PRODUCT CHANGE NOTIFICATION

Product Category REELSMART 20210520-1

Product Group TIES AND TERMINALS

ISSUE DATE: 11-Jan-21

Photos/Drawing (where applicable)

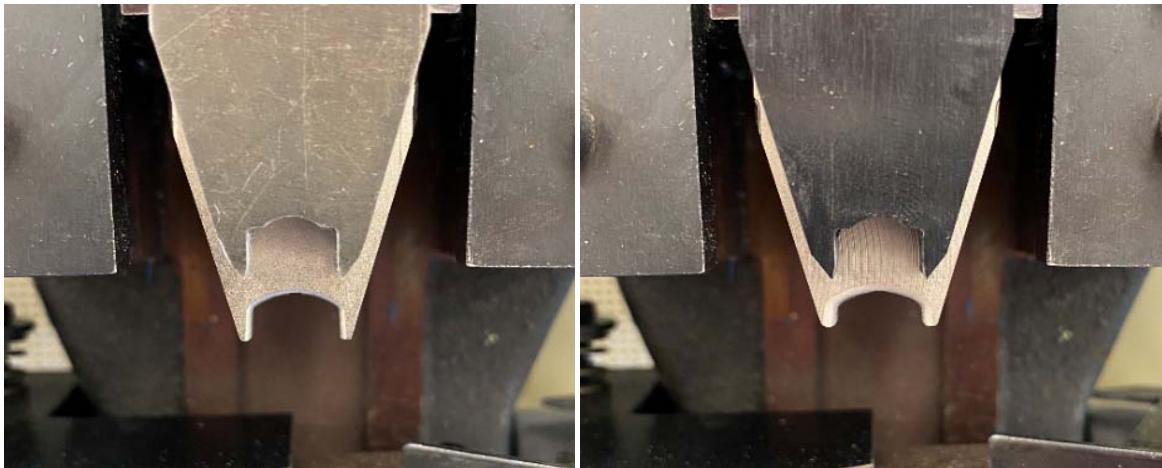
A change has been made to the upper crimp die of CD-800-3 (orderable component: TD13475C06) that is used with the CA-800EZ ReelSmart applicator. The side walls of the crimp die have been shortened by 0.05 inches to optimize the crimp performance. This change will not affect the product's compliance to industry standards.
